SR 30/US 280 @ Oconee River & Overflows

BR000-0001-00(366), P.I. No. 0001366
Wheeler & Montgomery Counties, Georgia

Value Engineering Study Report

September 2010

Sketch ^{2/17}
 Alt. P-2

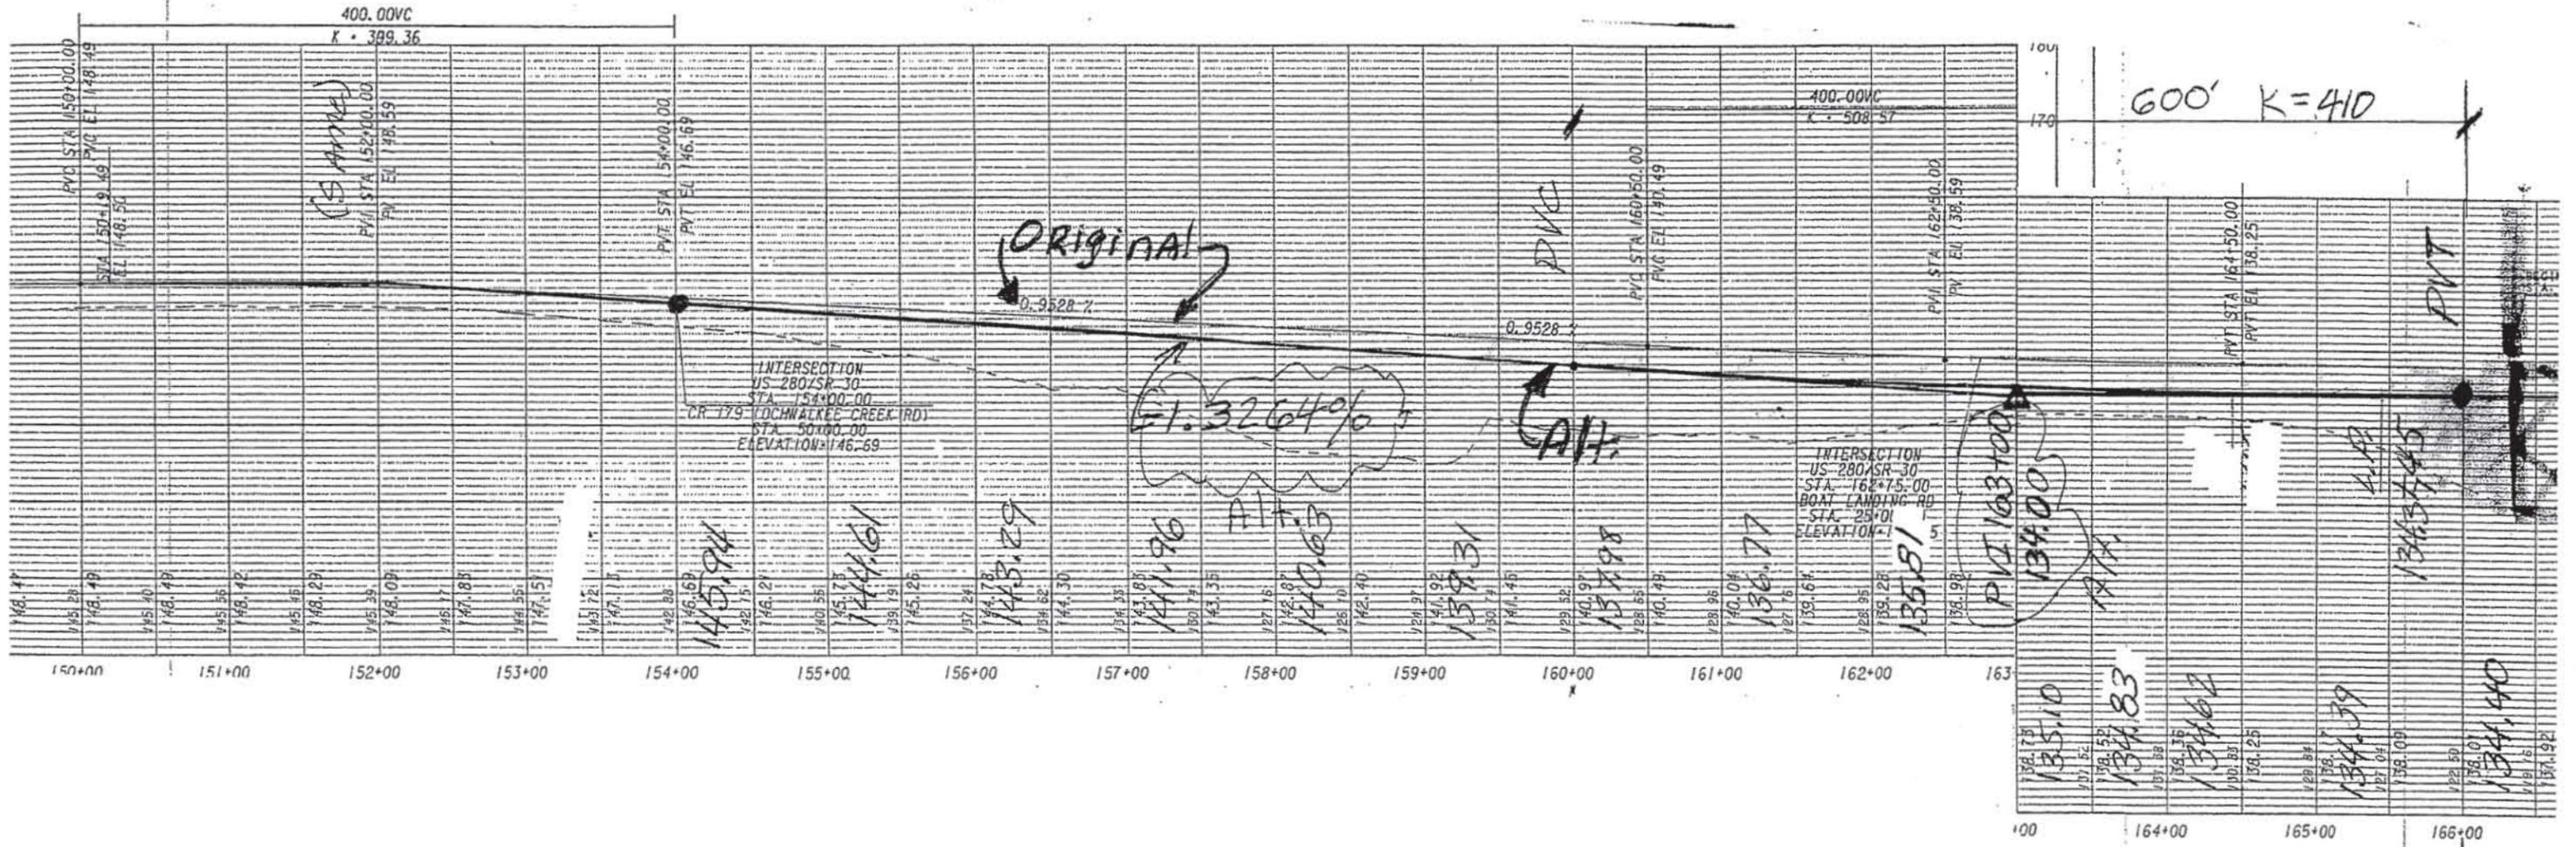
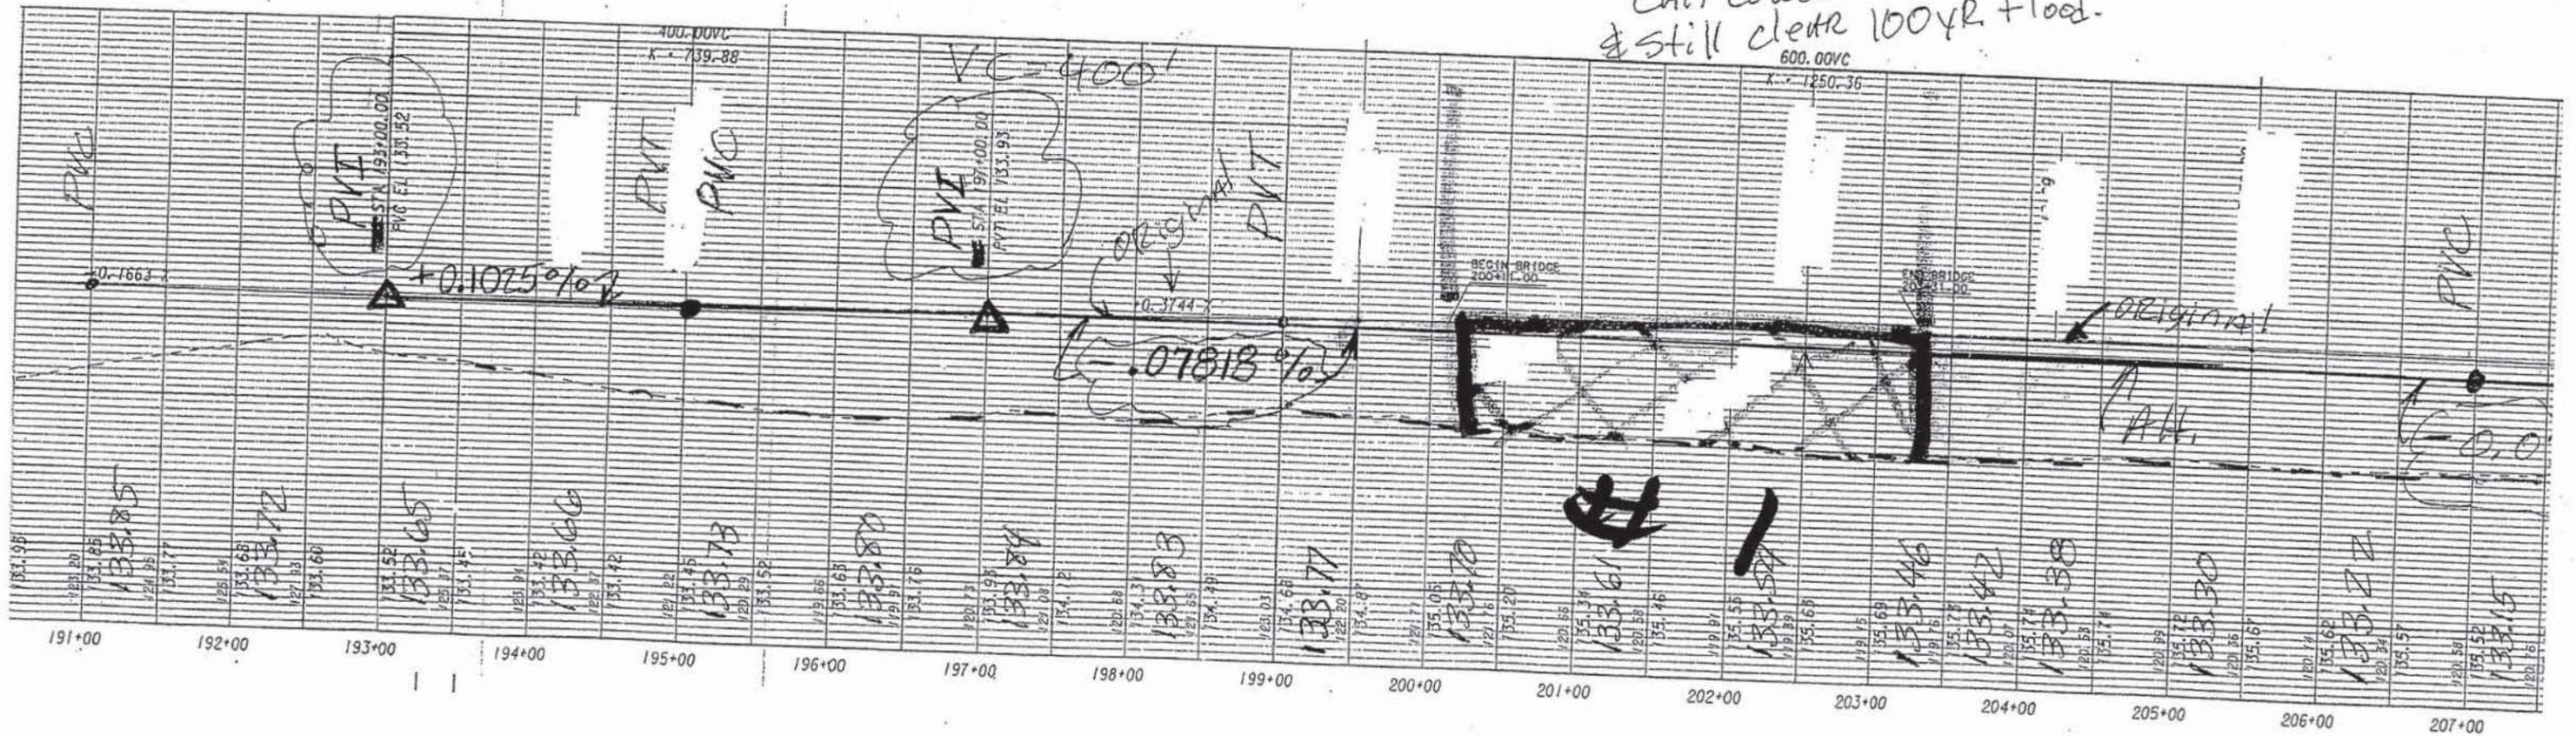
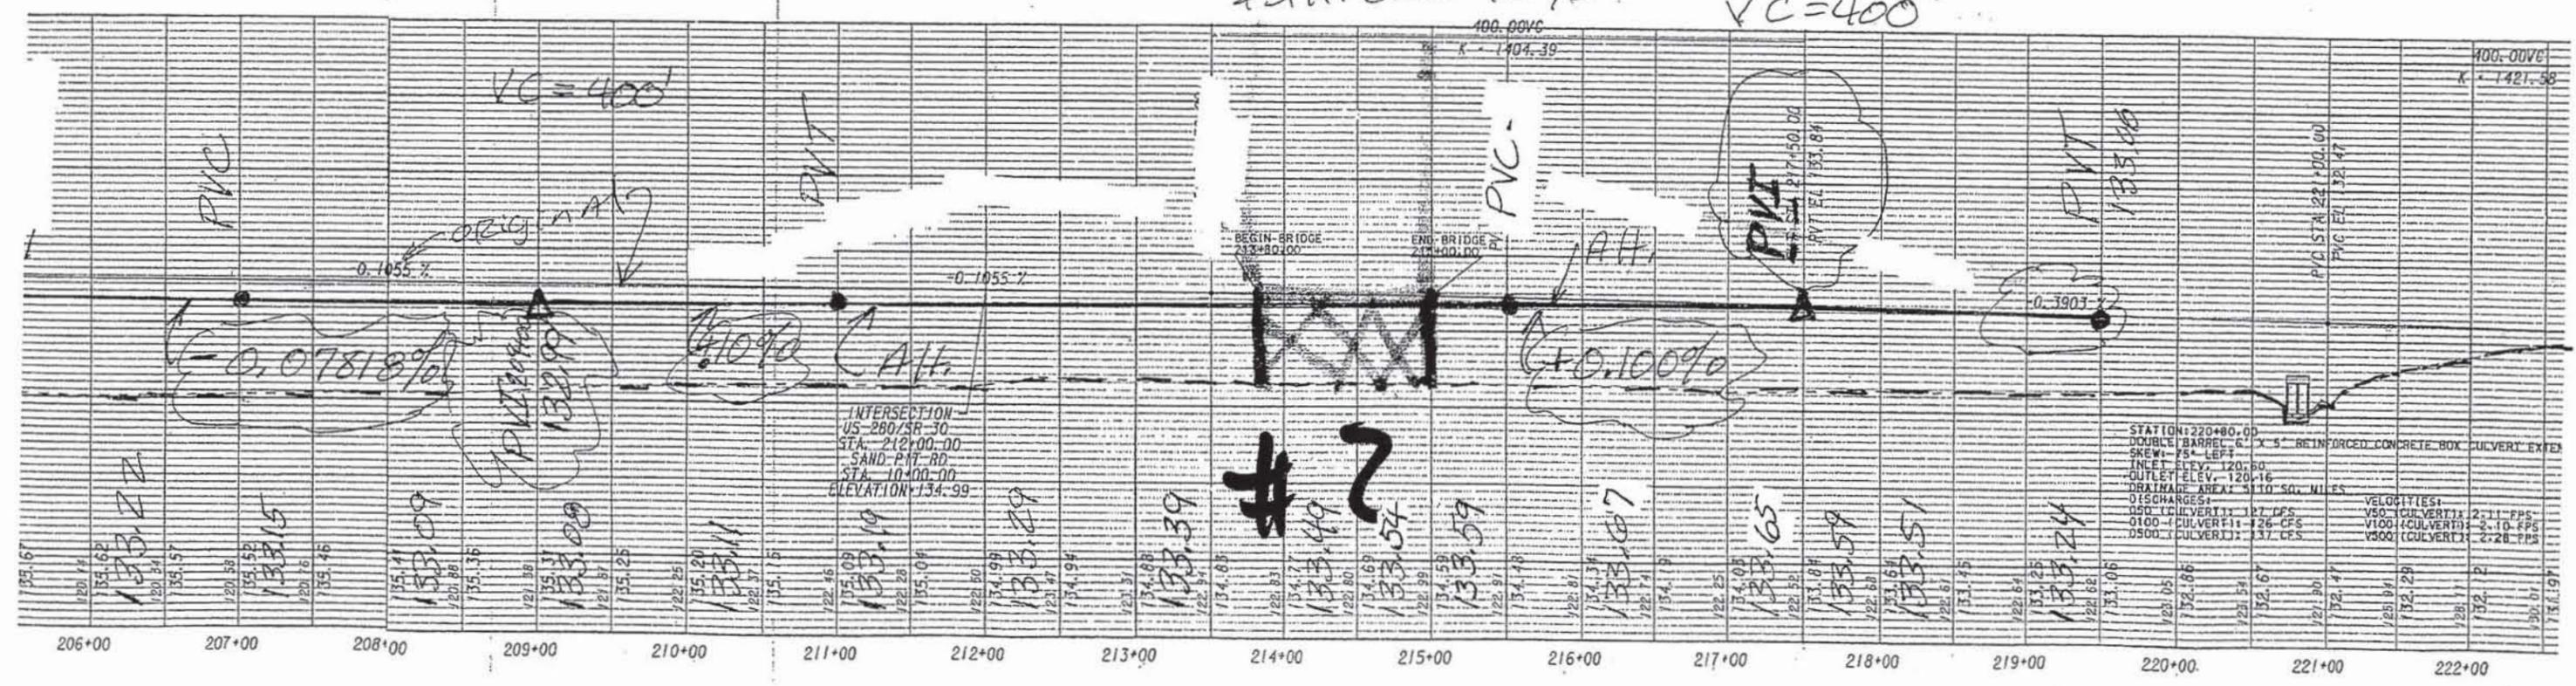
PROJECT: SR 30 / US 280 @ OCONEE RIVER & OVERFLOWS <i>BR000-0001-00(366), P.I. No. 0001366</i> <i>Wheeler & Montgomery Counties, GA – Preliminary Engineering</i>	ALTERNATIVE NO.: P-2
DESCRIPTION: LOWER PROFILE ON THE WEST END BY 1 TO 2 FT. TO TO REDUCE BORROW QUANTITIES	SHEET NO.: 1 of 7

The current roadway design profile is higher than the 100 yr. flood elevation.

The current design will require approximately 150,000 CY of borrow material mainly because of the profile that is required to “clear” the 100 yr. flood stage elevation. However there is enough clearance over the 100 yr. flood elevation to lower the roadway profile at select areas to reduce the amount of earthwork embankment. The alternative profile design will meet the design criteria for 65 mph. All of the side roads are lower in elevation than the mainline, therefore lowering the mainline profile will provide for flatter side road tie-in grades.

CAN Lower 2.93'
& still clear 100yr flood.

Can Lower 1.24'
still clear 100yr. flood
VC = 400'

ALTERNATIVE NO.:
B-12

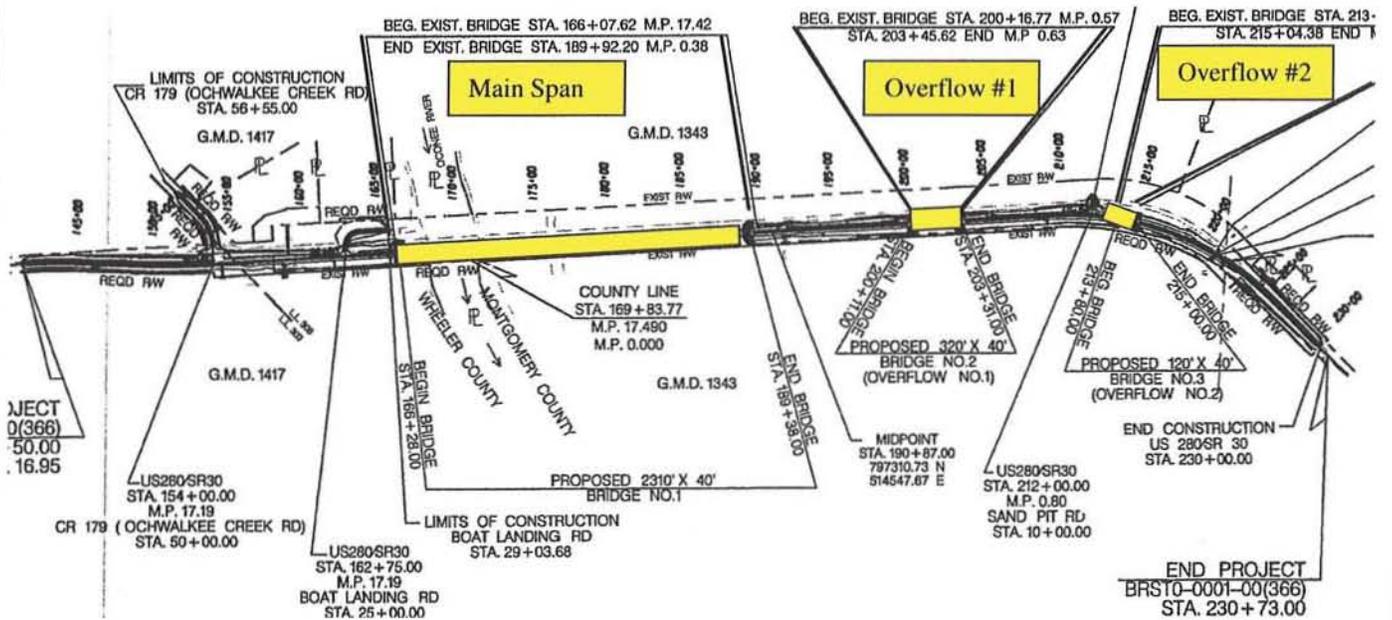
The design includes the replacement and demolition of the Main Span Bridge, Overflow No. 1, and Overflow No. 2 bridges. In the future, these structures will be replaced when the 4-lane facility is built. Projections show that the expansion to 4-lanes will be required in the year 2028, when traffic flows reach 10,000 vehicles per day.

ALTERNATIVE NO.:
B-12.1

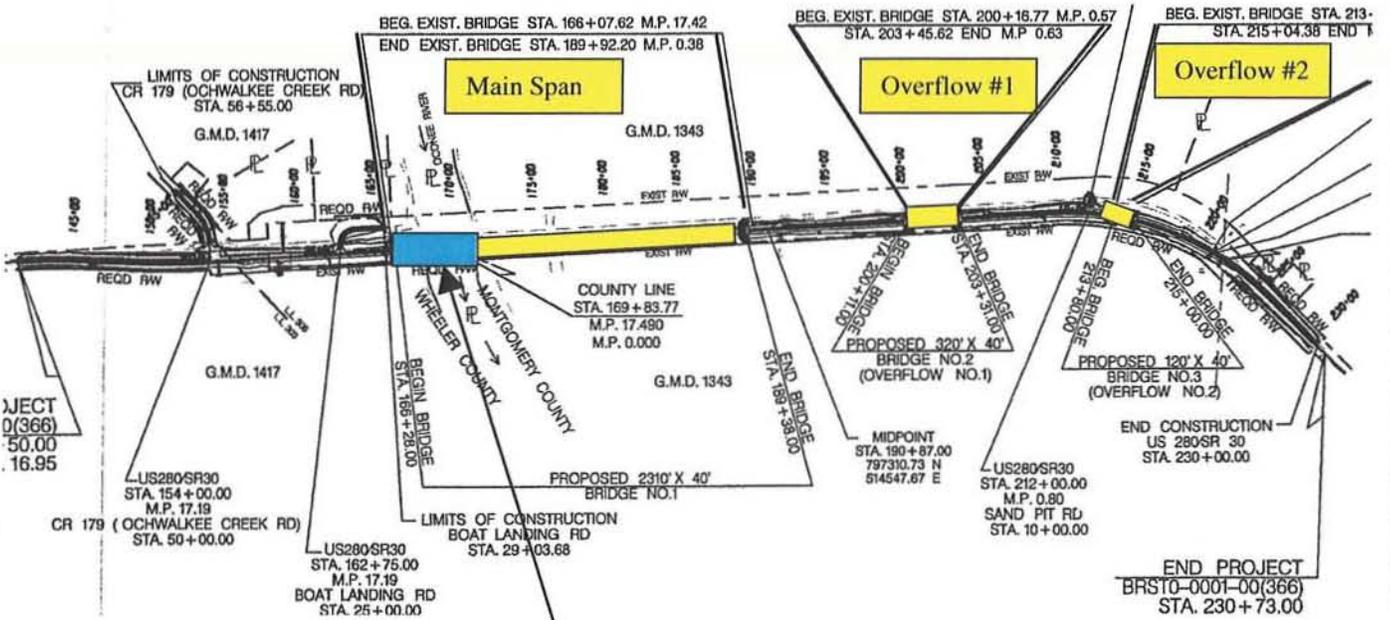
The design includes the replacement and demolition of the Main Span Bridge, Overflow No. 1, and Overflow No. 2 bridges. In the future, these structures will be replaced when the 4-lane facility is built. Projections show that the expansion to 4-lanes will be required in the year 2028, when traffic flows reach 10,000 vehicles per day.

**Demo the westerly
 700LF of Bridge No. 1
 (portion over river)**

CM-3
2 OF 3

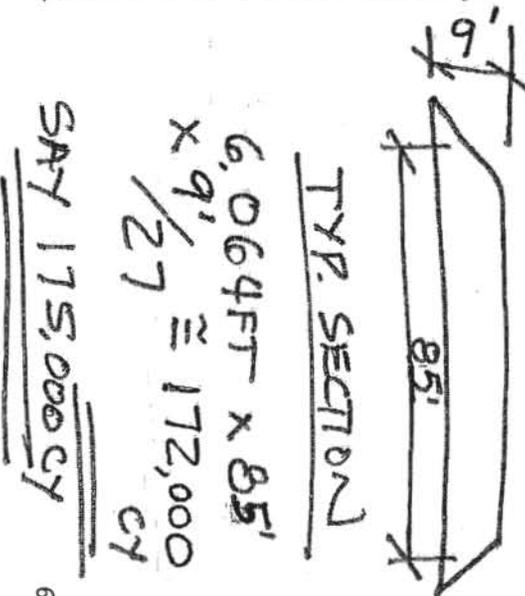
DESCRIPTION: REVISE THE EARTHWORK QUANTITIES FOR BORROW
 MATERIAL TO REDUCE THE RISK DURING THE
 BIDDING PHASE

If the project goes out to bid with the higher earthwork quantity, there would be substantial risk to GDOT in the form of potential change orders or higher unit prices with an unbalanced bid. Although the magnitude of this amount is difficult to assess, it is estimated that the exposure may be as high as 20% of the net overage in quantity.
